Memorandum

Subject Network Compliance Bulletin #13 (Underground Projects)

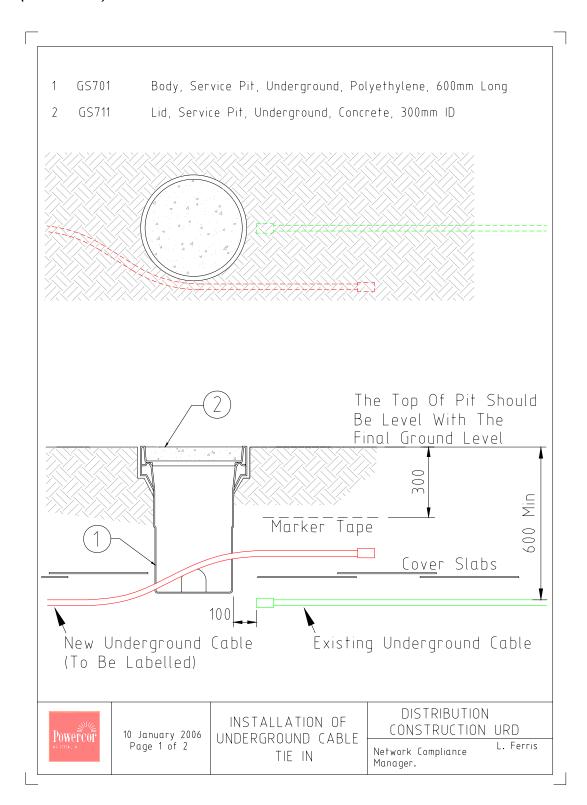
The constructor must first locate the existing cables, lay the new cable over the top of the existing cover slabs, leaving sufficient length to enable the joint to be completed and then install a pit 100mm from the end of the existing cable. Cover slabs and marker tape should be installed over the new cable as per standard GA211, the trench should then be backfilled and the nature strip reinstated if applicable.

Note: For tee joints the pit should be located directly above the proposed point of connection of the existing cable.

The ends of all new cables that may be part of a future extension must also be identified in the same manner by the installation of a pit 100mm from the end of the cable.
